UNITED STATES PATENT AND TRADEMARK OFFICE

APPLICATION NO.	FILING DATE	FIRST NAMED INVENTOR	ATTORNEY DOCKET NO.	CONFIRMATION NO.
10/619,688	07/15/2003	Felix A. Streiff	35666	8456
23589	7590	12/29/2005	EXAMINER	
HOVEY WILLIAMS LLP 2405 GRAND BLVD., SUITE 400 KANSAS CITY, MO 64108			COOLEY, CHARLES E	
			ART UNIT	PAPER NUMBER
			1723	
DATE MAILED: 12/29/2005

FINAL OFFICE ACTION (AFTER RCE)

FIG. 1

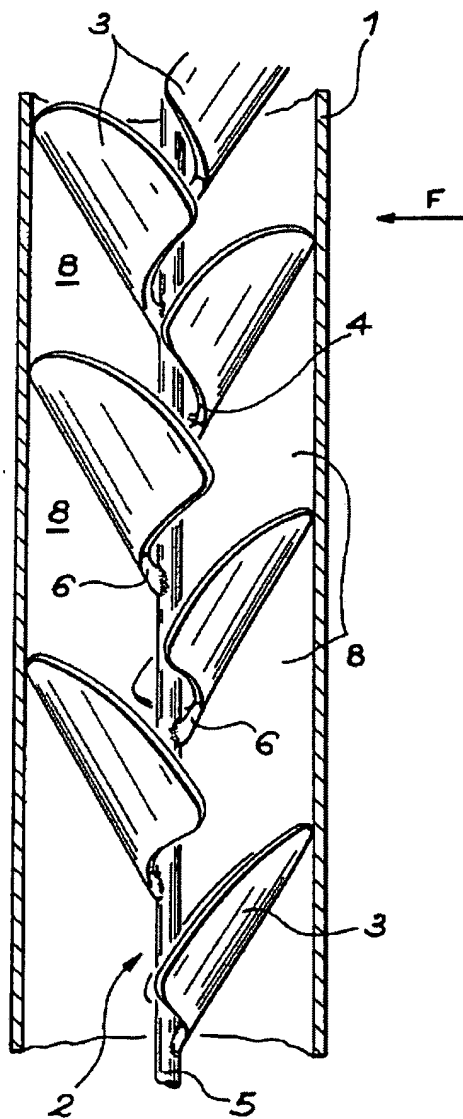
WO 98/47791 discloses a static mixer as seen below comprising a static mixer assembly (Fig. 1) with a generally ring-shaped fluid flow conduit 1 having a central axis (along 5), concentric inner and outer, radially spaced, circumferentially extending surfaces, said inner surface defining a fluid flow path which extends along said axis; one or more static mixers 2 located in said flow path, each static mixer having a plurality of spaced crossing elements forming one or more first grids (the elements 3 on the left side of the conduit 1 in Figure 1) and one or more slots 8 positioned between and

adjacent to each crossing element 3 of the one or more first grids; a second plurality of spaced crossing elements forming one or more second grids (the elements 3 on the right side of the conduit 1 in Figure 1) and one or more slots 8 positioned between and adjacent to each crossing element 3 of the second grids; wherein said crossing elements 3 of said first grid(s) are arranged at intersecting angles to said crossing elements 3 of said second grid(s), and wherein said grids are arranged such that each crossing element 3 of one grid intersects and extends at least partially through a slot 8 in the other grid (i.e., note the crossing elements 3 of the first and second grids at least partially circumferentially overlap such that portions of the crossing elements extend into slots of the opposing grid(s) as seen in Figure 1); at least one elongated connector 5 positioned between and secured to said crossing elements 3 of said first grid(s) and said crossing elements of said second grid(s); wherein said crossing elements 3 of said first grid(s) are in a generally parallel relationship relative to one another (Fig. 1); wherein said crossing elements 3 of said first grid(s) lie within a common plane (the plane to the left of the axis defined by connector 5); wherein said crossing elements 3 of said second grid(s) are in generally parallel relationship relative to one another (Fig. 1); wherein said crossing elements of said second grid(s) lie within a common plane (the plane to the right of the axis defined by connector 5); wherein said crossing elements are corrugated plates (a groove on the concave side parallel to the peak on the convex side); wherein the static mixer comprises more than two grids with each grid comprising crossing elements 3 (note Fig. 1 is a broken view depicting a plurality of crossing elements spaced along the axis of the conduit and since but two crossing elements on

each of the opposite sides of the connector can constitute a grid, a multitude of grids are spaced along the length of the conduit); wherein said connector 5 extends continuously along the entire cross-sectional length of said static mixer (Fig. 1); wherein said elongated connector 5 is positioned so that it intersects with said crossing elements along at least some of their points of intersection (Fig. 1). Although the product-by-process subject matter of claim 41 is not germane to the patentability of the product, note the crossing elements 3 are apparently secured to said connector 5 by welding (proximate 6 in Fig. 1).

WO 98/47791 also discloses a method of constructing a static mixer, in light of the explanations above, comprising providing at least two grids; positioning at least two spaced crossing elements 3 and one or more slots 8 between and adjacent to each crossing element 3 in a first grid; positioning at least two spaced crossing elements 3 and one or more slots 8 between and adjacent to each crossing element in a second grid; arranging said crossing elements 3 of said first grid at intersecting angles to said crossing elements 3 of said second grid; arranging said grids such that each crossing element of one grid intersects and extends at least partially through a slot 8 in the other grid; positioning at least one connector 5 between said crossing elements 3 of said first grid and said crossing elements 3 of said second grid; and securing said connector 5 to said crossing elements 3; providing more than two grids along the length of the conduit 1; and positioning one or more crossing elements 3 in each grid.

WO 98/47791 discloses that the connector 5 is positioned between said crossing elements 3 of each grid as seen in Figure 1 but does not disclose the crossing elements of each grid being arranged at intersecting angles to one another. The patent to Katzen '618 discloses in Fig. 5 a static mixer comprising spaced grids of crossing elements 29 that are secured to a central connector 28. The crossing elements 29 of adjacent grids are arranged at intersecting angles to one another as seen in Fig. 5. It would have been obvious to one having ordinary skill in the art, at the time applicant's invention was made, to have modified the arrangement of the grids in WO 98/47791 such that crossing elements of each grid are arranged at intersecting angles to one another as disclosed by Katzen '618 for the purpose of providing a highly effective sheer action on the fluid and providing a swirl action (col. 4, line 43 through col. 5, line 3).

WO 98/47791 does not disclose the recited materials of the crossing elements but apparently shows the crossing elements 3 secured to the connector 5 by welding (proximate 6 in Figure 1). Assuming this is not the case, the patent to Horner '188 discloses a static mixer 20 and a method of constructing said static mixer comprising providing a first grid 32 comprising one or more crossing elements 38 and one or more slots adjacent to each crossing element 38 (Fig. 2 and col. 4, lines 60-63) and providing a second grid 34 comprising one or more crossing elements 38' and one or more slots adjacent to each crossing element 38' (Fig. 2 and col. 4, lines 60-63) wherein said crossing elements 38 of said first grid 32 are arranged at intersecting angles to said crossing elements of said second grid (Fig. 2 and col. 4, lines 19-23); and positioning at least one elongated connector 36 positioned between and secured to said crossing elements 38 of said first grid and said crossing elements 38' of said second grid; said grids 32, 34 are arranged such that each crossing element of one grid intersects a slot in the other grid (Fig. 2); said crossing elements 38 of said first grid 32 are in a generally parallel relationship relative to one another (col. 3, lines 60-64); said crossing elements 38 of said first grid 32 lie within a common plane (Figs. 2 and 4); said crossing elements 38' of said second grid 34 are in generally parallel relationship relative to one another (col. 3, line 67 through col. 4, line 3); said crossing elements 38 of said second grid lie within a common plane (Figs. 2 and 4); said crossing elements are one of corrugated plates and tubes (col. 5, lines 37-48); the static mixer 20 comprises more than two grids
